Title: TUBE STYLE CYLINDER RACK
(1) WIDE BY (2) DEEP
WITH ELECTROGALVANIZED STEEL CHAINS

SUBMITTAL IDENTIFICATION SHEET

WEBSTER UNIVERSITY ISB
PROJECT NAME

123553-001 REV 2
CONTRACTOR / CM SUBMITTAL NO.

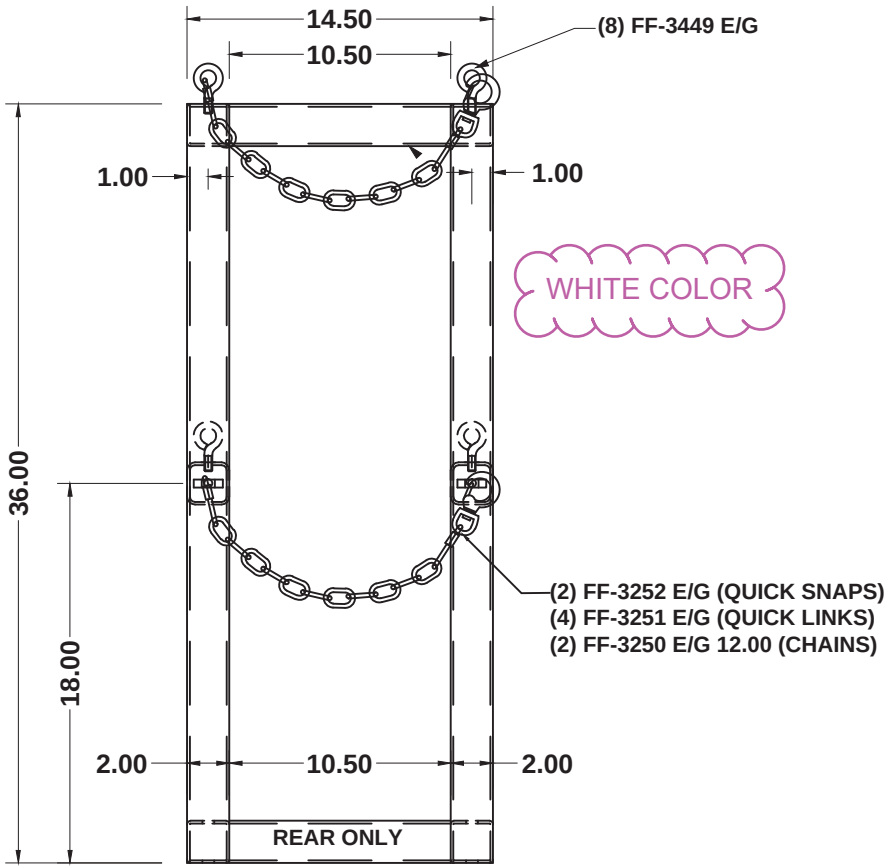
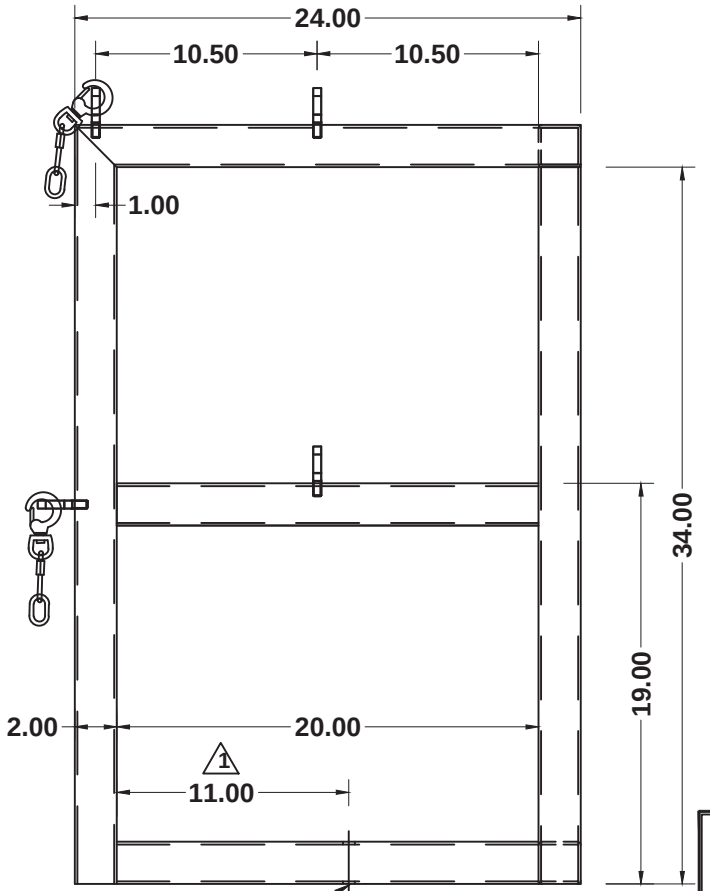
WHITE COLOR

cylinder racks were not previously included.

GC TO REVIEW THESE WITH OWNER FOR FINAL APPROVAL.

-PROVIDE WHITE COLOR CYLINDER RACKS.
